Minutes
Cascade Charter Township
Planning Commission
Monday, November 13, 2023
7:00 pm
2870 Jacksmith Ave SE

STAFF REPORT: Case # 22-3798
REPORT DATE: October 27, 2023
PREPARED FOR: Cascade Charter Township Planning Commission
MEETING DATE: November 13, 2023
PREPARED BY: Madison Smith-Jacoby

STAFF REPORT: Case # 23-3795
REPORT DATE: November 4, 2023
PREPARED FOR: Cascade Charter Township Planning Commission
MEETING DATE: December 4, 2023
PREPARED BY: Madison Smith-Jacoby, Zoning Administrator

STAFF REPORT: Case # 23-3800
REPORT DATE: November 17, 2023
PREPARED FOR: Cascade Charter Township Planning Commission
MEETING DATE: December 4, 2023
PREPARED BY: Madison Smith-Jacoby

SITE PLAN

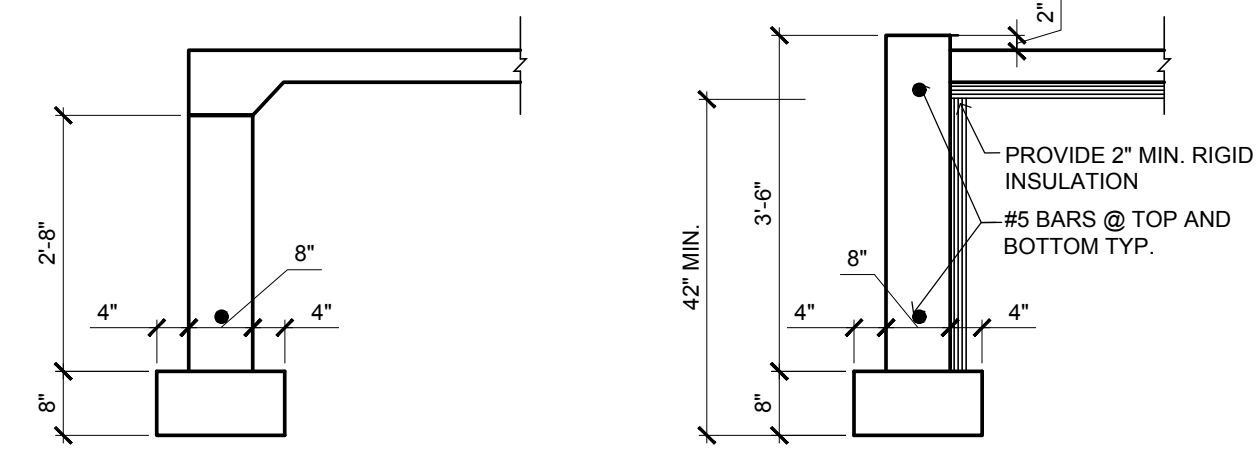
Factors	Comment
The intended use of the building.	Personal storage and personal woodworking shop with roof-mounted solar panels.
The proposed location, type and kind of construction and general architectural character of the building.	The design is proposed to match the existing house and the building is set in the backyard.
The size of the building in relation to the house, lot and zoning district.	The home is 3, 729sqft so the accessory building is less than half the size. The zoning district has permitted an average size of 2,170sqft. for an accessory building.
The type and kind of principal and accessory buildings and structures located on properties which are adjoining and in the general area.	In the general area there is a range of PUD homes with attached garages and various accessory buildings ranging from 500sqft to 1,440sqft. The applicant received a special use permit for his property across the street.

Whether the proposed building will affect the light and air circulation of any adjoining properties.	The neighboring parcels would not be impacted. One is vacant (owned by Alan Salmon) and the parcel to the south is permanent Common Element for the PUD.
Whether the proposed building will adversely affect the view of any adjoining property owner or occupant.	No negative impact observed due to previous box reasons and the applicant's plan to keep as many trees as he can.
Points of access to the proposed building and their relationship to adjoining properties and the view from the adjacent streets.	The proposed access is shown as a drive extending from the main home's parking/driveway pad.

EXISTING SITE PLAN
SCALE: NO SCALE

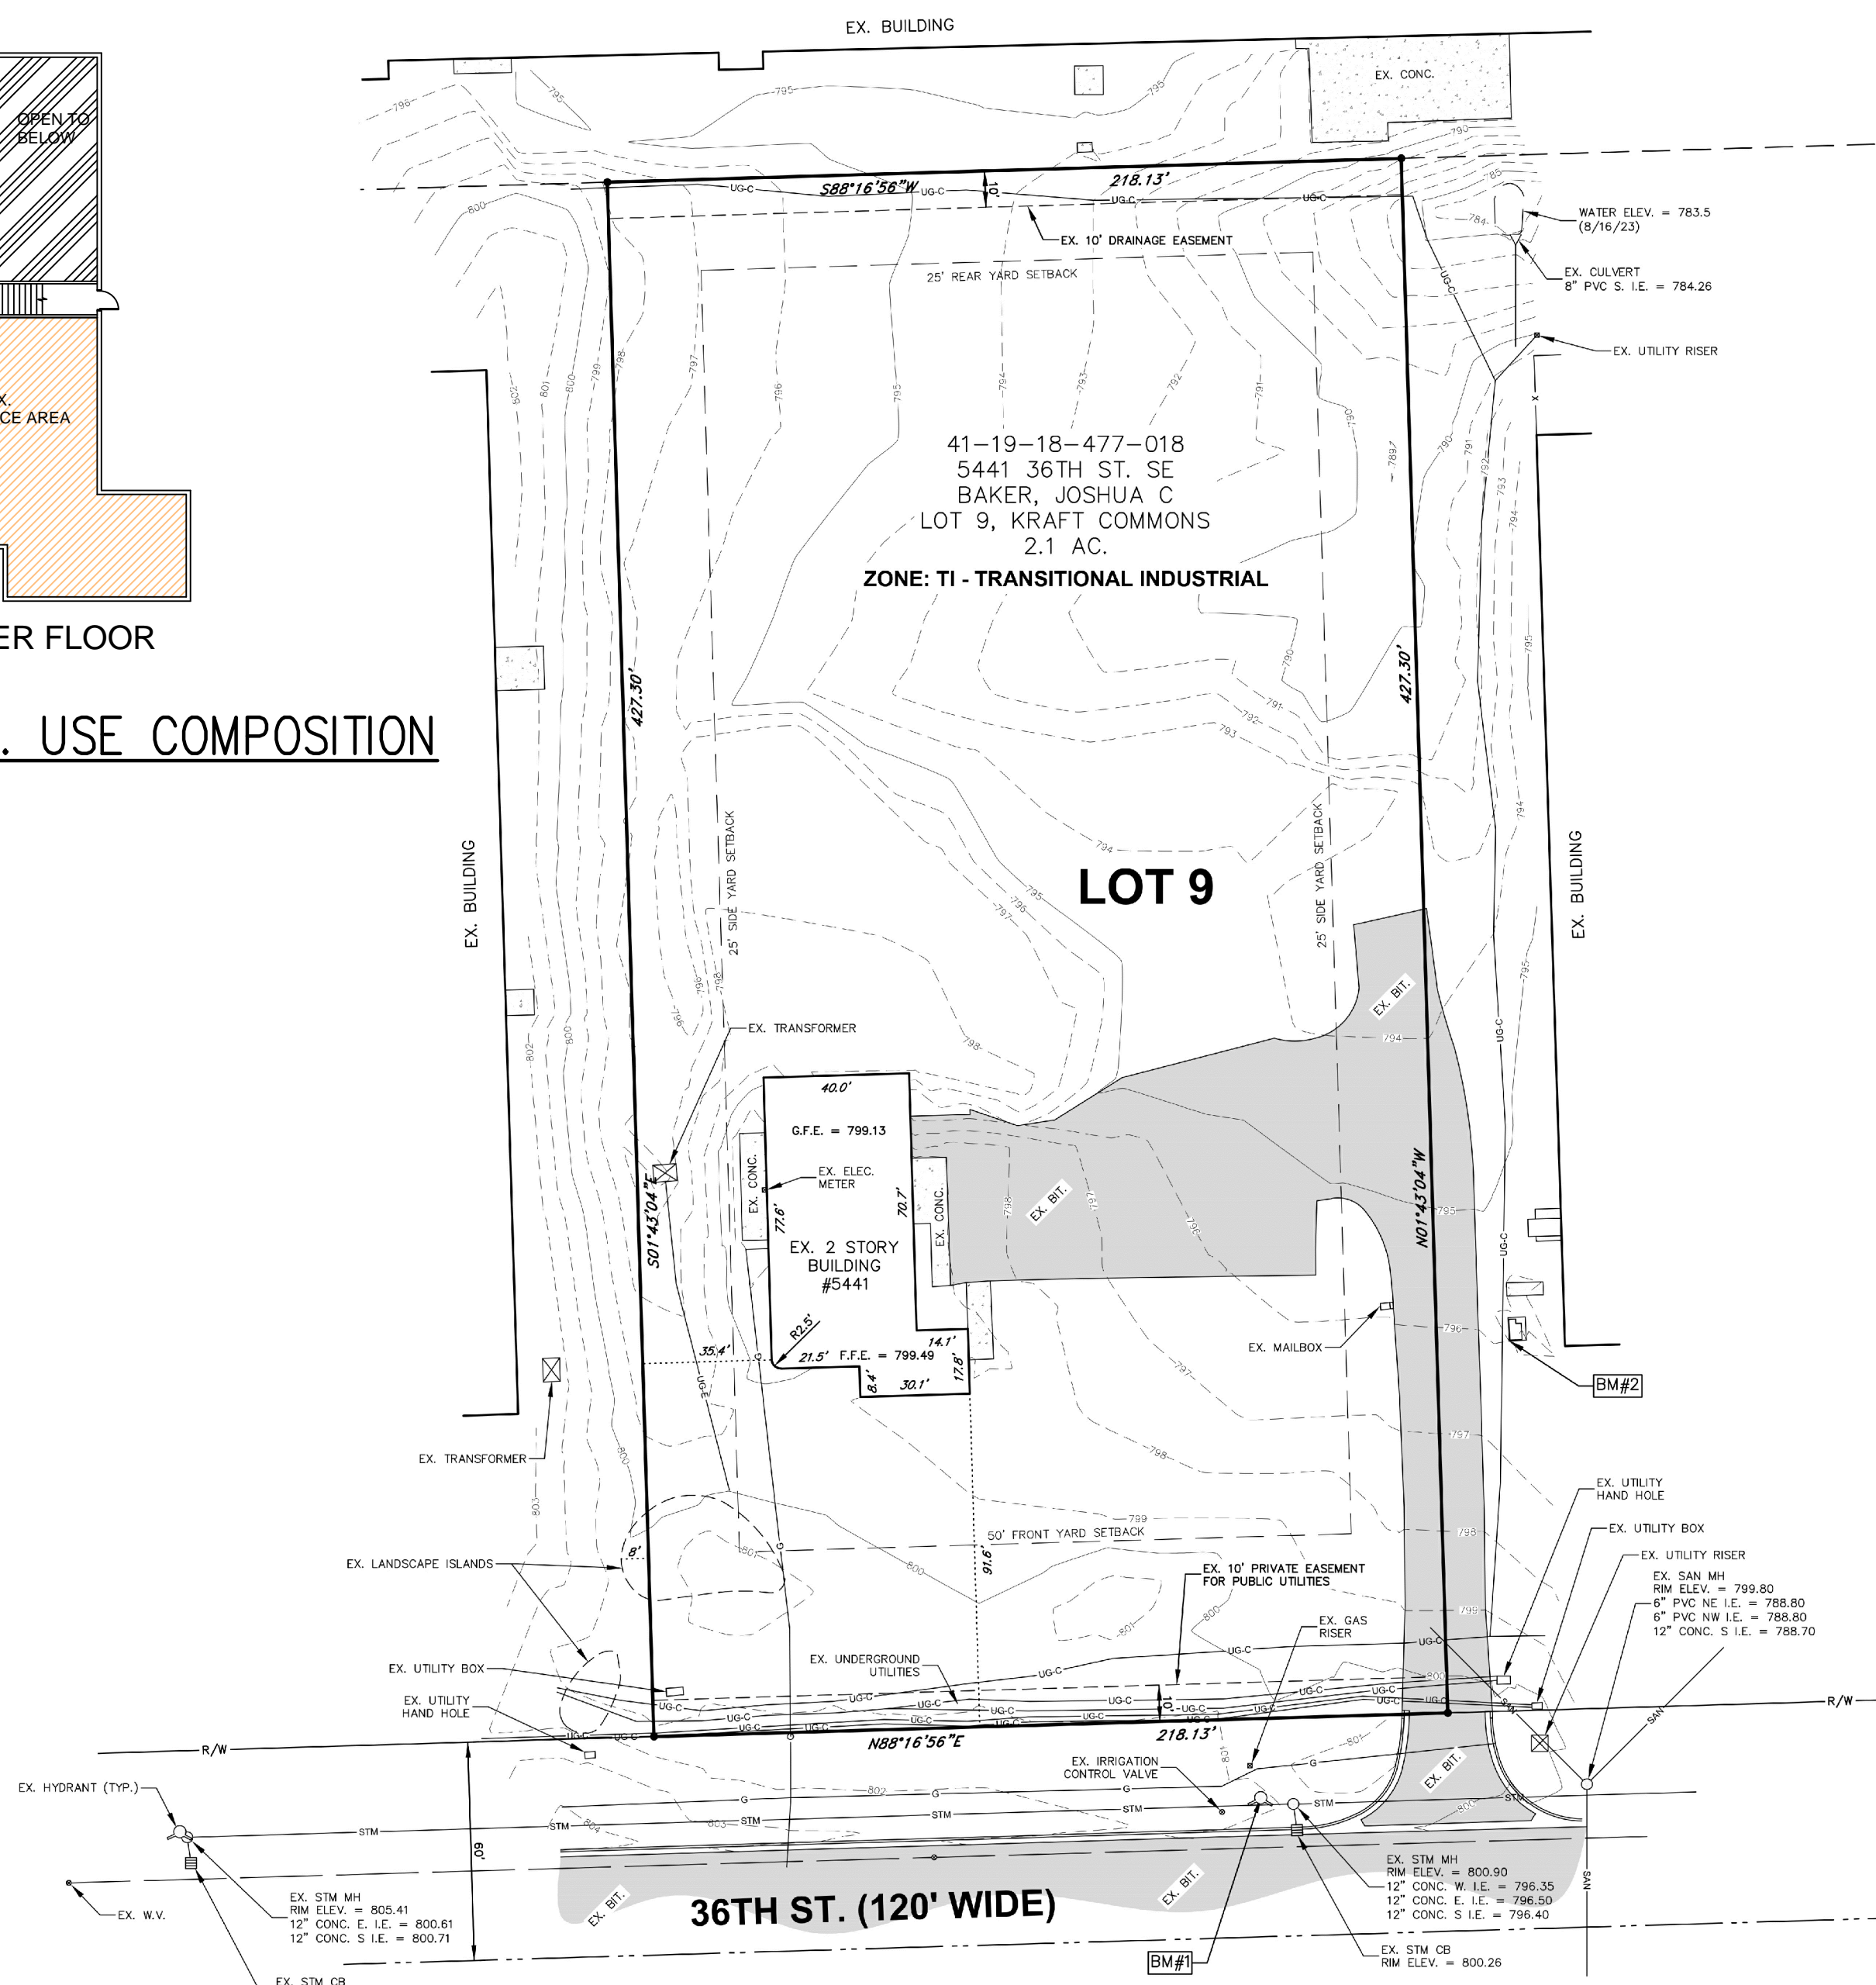
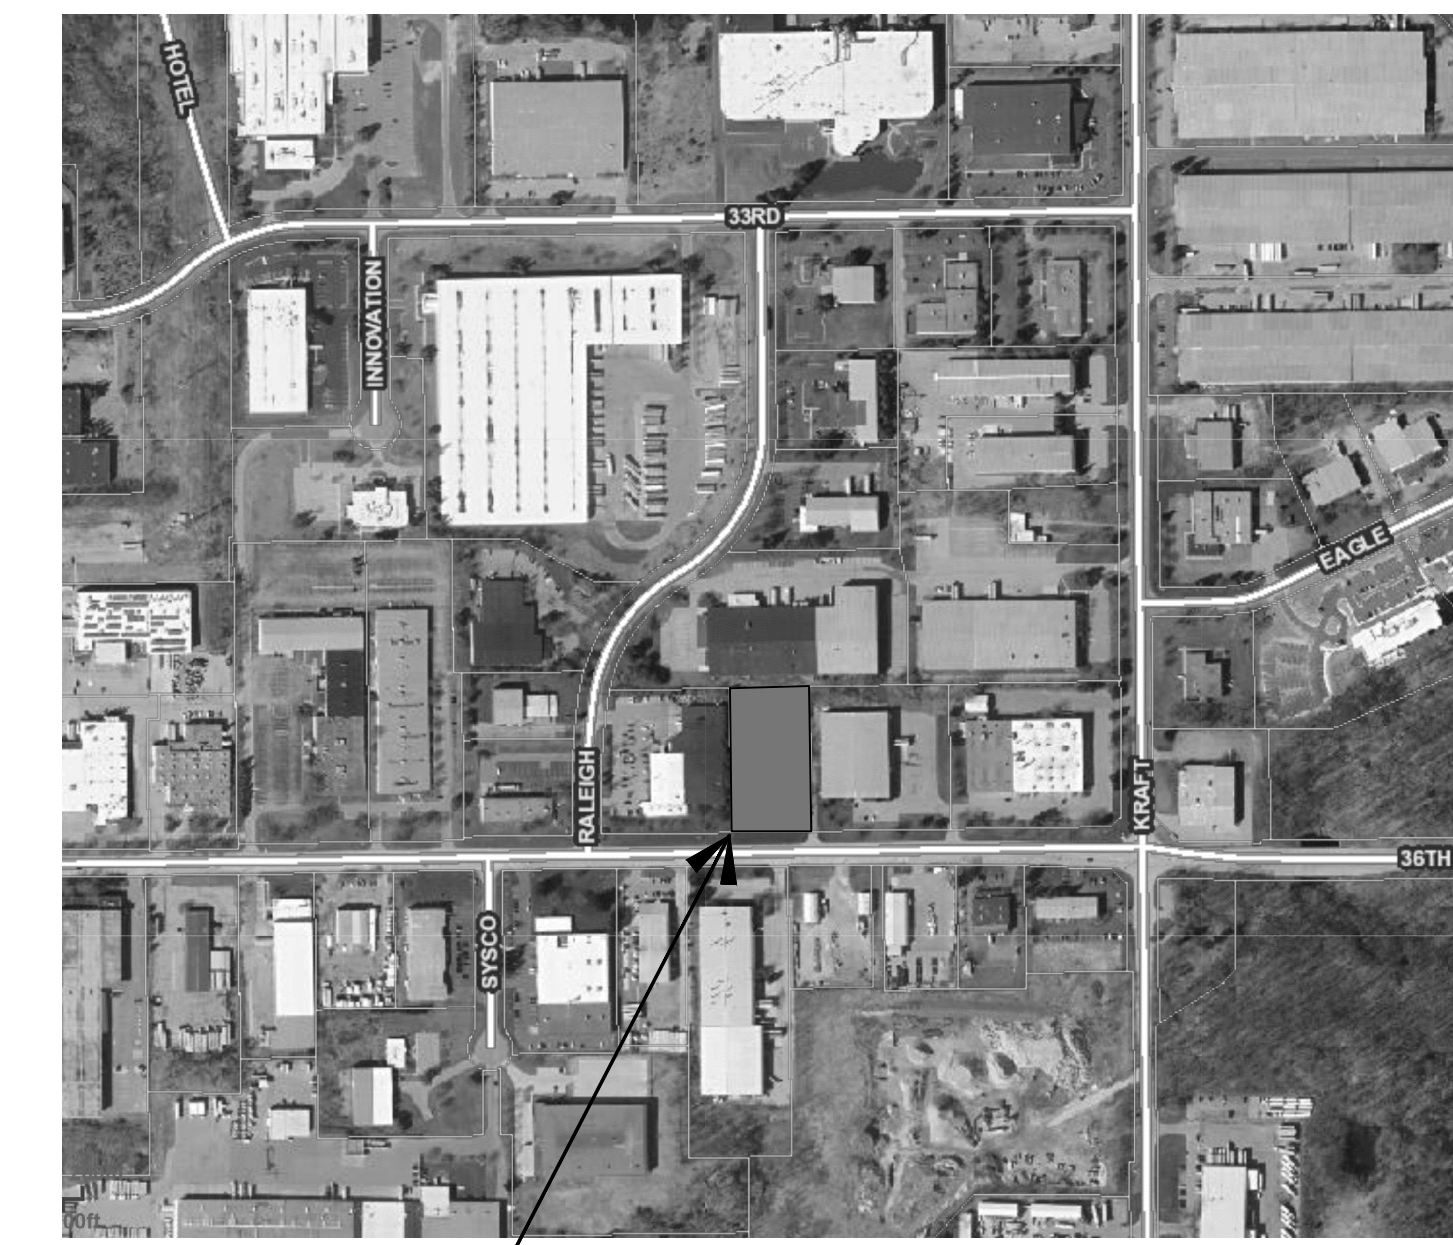
3. Also included on the plans is an addition of trucking doc, parking lot, and retention pond. The site plan was reviewed under the criteria of Section 21.07 of the Site Plan Review Chapter of the Zoning Ordinance.

The plan indicates a total of 23 spots. The Planning Commission should determine if this number of parking spaces will suffice for the presented use. Deferring parking spaces has been approved in the past for applicants until the parking is needed or the Township requires it. The applicant defers 7 spaces.

1. Execute the storm water agreement.
2. Provide a landscape bond for \$5,000.

BASIN OVERFLOW SPILLWAY
NOT TO SCALE

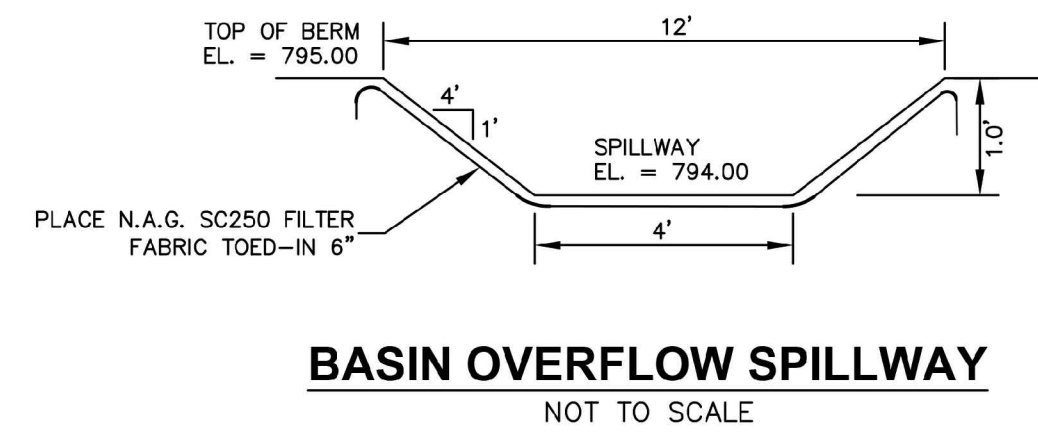
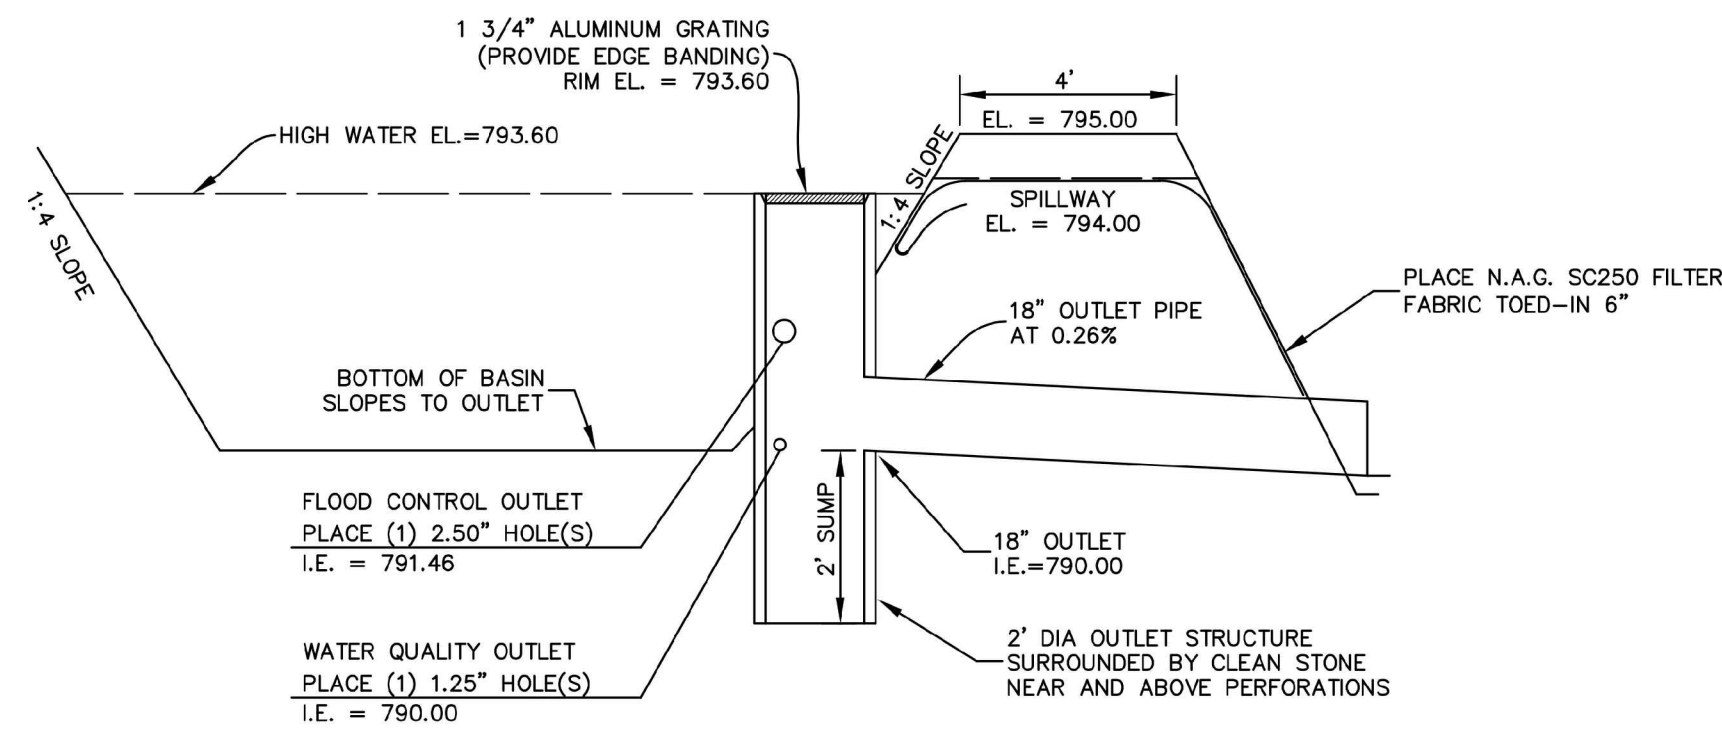
Water quality and channel protection are provided through the on-site detention basin. The design accounts for both water quality (4,268-cft) and channel protection (3,205-cft) quantities. A forebay is included in the basin with calculations supporting requirements. The minimum 1-ft of freeboard, or 0.5-ft above the design flow depth over the spillway, is included; and the primary and emergency overflows account for the 10-year peak inflow at the maximum design high water level. Plans include a section detail for the basin overflow spillway.
